# Service Bulletin

**Model:** **STR-D2020** **No.** 268

**Subject:** Unit Getting Hot, then Goes Into Protect **Date:** May 29, 1992

**[MAIN POWER BOARD]**

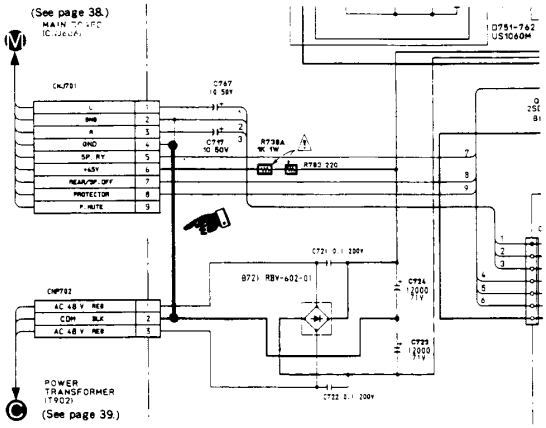
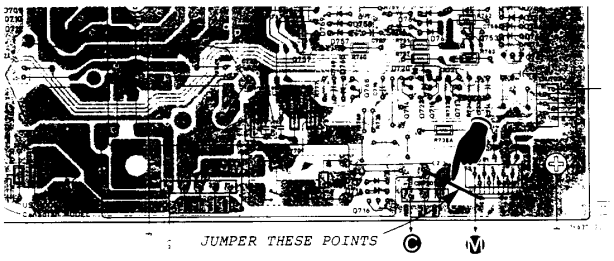
**Symptom:**
**(12)** Unit gets very hot, then goes into protect.

**Solution:** Short the power supply ground to the audio ground as shown below:
